Emily Koide
Technical Advisor I
Nunavut Impact Review Board

Re: Agnico Eagle's response to Meadowbank (03MN107) and Whale Tail (16MN056) 2021 Annual Report comments

The following information are intended to address regulator's comments regarding the Meadowbank (03MN107) and Whale Tail (16MN056) 2021 Annual Report:

Figure 1.2-1: Airblast overpressure versus distance for spring and winter seasons. Dashed lines represent 95% confidence intervals.

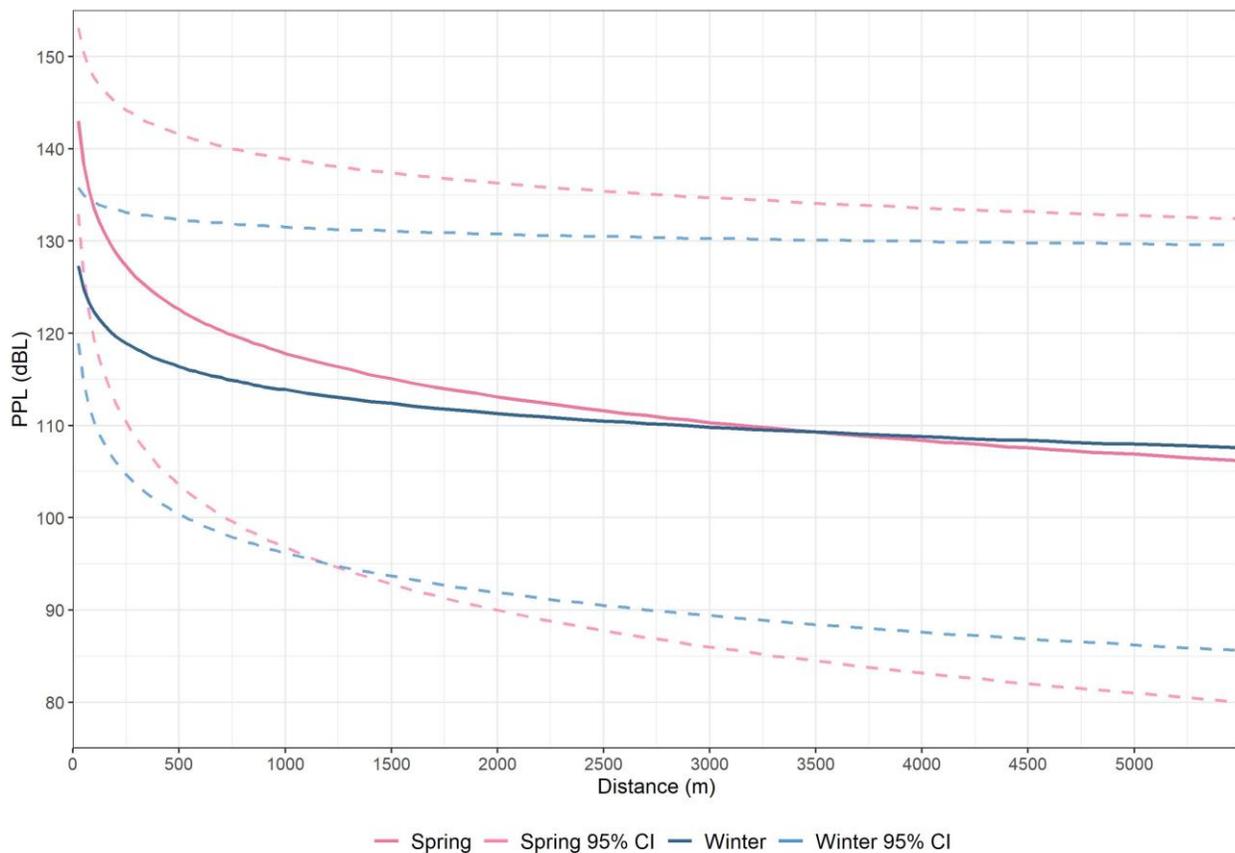
It is unclear whether this conclusion of 'no seasonal difference' is based on a statistical analysis or a subjective review of the curves presented in figure 23. If based on the latter, an alternative conclusion can be reached. For example, visual inspection of figure 23, indicates the Peak Pressure Level (PPL), which characterizes air-blast overpressure, reaches 115 decibels (dB, a published human annoyance threshold cited in the Report) at 0.75 km and 1.5 km during winter and spring blast, respectively. If true, this suggests that sound, at levels known to be annoying to people, propagates twice as far in spring compared to winter. This has important implications for informing blasting distance buffers to mitigate disturbance of wildlife such as spring migrating caribou.

1. That Proponent clarify whether the conclusion that blasting over-pressure shows no seasonal difference in propagation distance is based on statistical significance. If based on a statistic analysis, please provide the details of the analysis.

Agnico Eagle's Response: *Figure 23 of the 2021 Annual Report presents a PPL vs. distance curve established through application of regression analysis to all 174 PPL measurements collected between December 20, 2020 and August 6, 2021. Figure 23 also presents the 95% confidence interval for the "all blasts" curve (i.e., the range within which one can be 95% confident that the true relationship between PPL and distance will fall). In addition, Figure 23 presents separate PPL vs. distance curves established through application of regression analysis to the 49 PPL measurements collected during the spring period, the 42 PPL measurements collected during the summer period, the 11 PPL measurements collected during the fall period, and the 72 PPL measurements collected during the winter period.*

Please note that 95% confidence intervals were also calculated for the individual seasonal curves but, in the interest of clarity, these confidence intervals were not plotted in Figure 23 of the 2021 report. Exceedance outside of the 95% confidence interval would indicate statistical significance (Nakagawa and Cuthill 2007). In response to GN's specific concern about propagation of PPL during the spring and winter periods, Figure 1.2-1 presents PPL vs. distances curves established through application of regression analysis to the 49 PPL measurements collected during the spring period and the 72 PPL measurements collected during the winter period, along with 95% confidence intervals for each curve.

than 100 m, the spring curve lies within the 95% confidence interval established for the winter period and the winter curve lies within the 95% confidence interval established for the spring period. This result supports the observation that it is not currently possible to identify a statistically significant difference in the way that PPL propagates into the environment.

The observation that data collected to date does not suggest a seasonal difference in the way PPL propagates into the environment does not rule out the possibility of a seasonal difference; however, the present analysis could not identify such a relationship based on the data that is currently available. A statistically significant seasonal difference may emerge with the collection and analysis of more data. As noted below, Agnico Eagle intends to continue to record blast location, charge mass and depth and will continue to analyze this data to establish relationships between PPL, propagation distance, and caribou response.

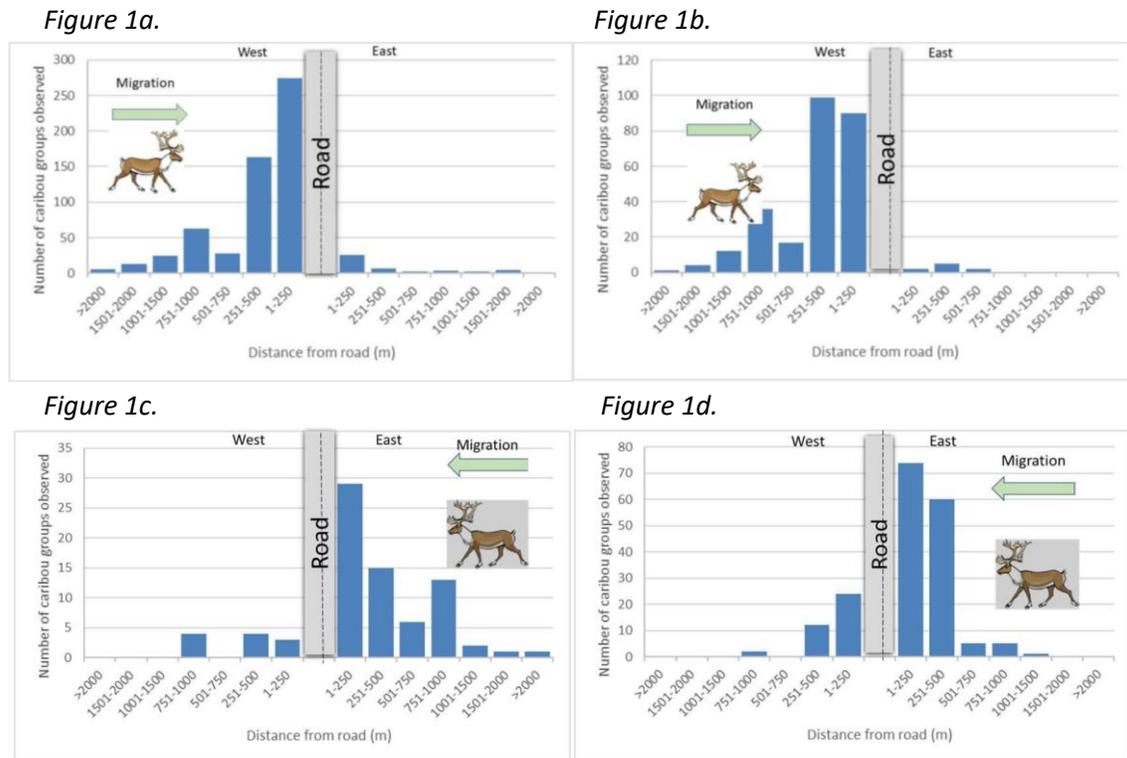
- a) Road survey data for the Project show that a vast majority of migrating caribou are observed on the side of a road facing the on-coming migration. This suggests that caribou movements are being blocked by the road and/or its traffic and consequently caribou are concentrating near the road as they attempt to cross it. An example of this is shown in figure 1 using the Proponent's 2019 road survey data for the Whale Tail Haul Road (HR) and AWAR. A similar pattern of caribou distribution is seen in all years for which data are available.

In response to point A above that road survey data for the Project show that a vast majority of migrating caribou are observed on the side of a road facing the on-coming migration, this observation is due to the monitoring approach targeting migrating groups as they approach the

road. Therefore, observations for the on-coming migrations side of the road will be biased high, and once a group or caribou is observed and counted, they are not counted after crossing. Further, the probability of detection increases as distance to the observers decreases, so the number of detections should be higher closer to the road. The distributions presented in Figure 1 are in line with expected observations for road surveys given the methodology and purpose of the program. Natural factors, such as habitat and topography, that may also be correlated with distance and explain the observed patterns but are not considered. Interpreting these distributions as caribou being blocked from crossing and/or concentrating on the on-coming migration side of the road are not supported by these data.

(Figure extracted from Figure 7 of: Whale Tail Project – Meadowbank Complex 2021 Annual Report – Closure and Post-Closure Water Quality Predictions (Golder, March 2022) as presented in Appendix D of Appendix 13 to AEM's 2021 Annual Report)

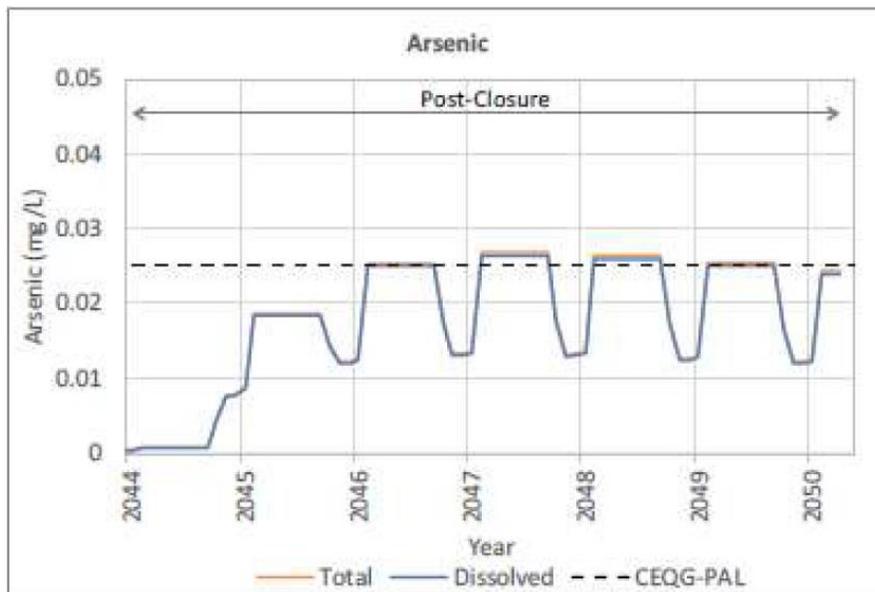
Increased concentrations of some parameters (e.g., arsenic) and increased water volumes should, in theory, result in higher contaminant loadings to surface water receivers. While this is effectively managed by AEM during operations, higher loadings during the post-closure phase have the potential to result in adverse impacts to surface water receivers. Nonetheless, CIRNAC notes that AEM's updated water quality predictions (as presented in Appendix 13) are generally similar to those presented in the FEIS for the Expansion Project. Specifically, as illustrated in the following figure, average arsenic concentrations in Mammoth Lake during the postclosure phase are currently predicted to slightly exceed the arsenic SSWQO for several years. That prediction is generally similar to estimates that were presented in the FEIS for the Expansion Project.

It is unclear to CIRNAC why the increased arsenic loadings that have been observed during the operational phase (as indicated by pit sump water monitoring data) are not resulting in post-closure water quality predictions that are worse than predicted in the FEIS for the Expansion Project. Additional information is required on any adjustments AEM has made to the water quality prediction model.

Agnico Eagle's Response: *Agnico agrees with CIRNAC's recommendation to indicate which modelling parameters have been adjusted since the last modelling run and to explain situations where the level of conservatism has reduced relative to FEIS predictions. It should be noted that as per NWB Water License 2AM-WTP1830 Schedule B, Item 9, the complete water quality forecast model is updated yearly, and included in the Annual Report. Therefore, this recommendation will be included in next year water quality forecast model. The Whale Tail Interim Closure and Reclamation Plan refers to the water quality forecast model, but however does not include the modelling process in great details.*

Agnico Eagle's Response: *Agnico agrees with CIRNAC's recommendation for the next iteration of the water quality forecast model to explicitly report the range of predicted modelling outcomes based on model prediction accuracy. It will be ensured that the consultant performing the water quality forecast discusses the prediction accuracy of the model within the report as it is possible this may have changed since modelling was first performed.*
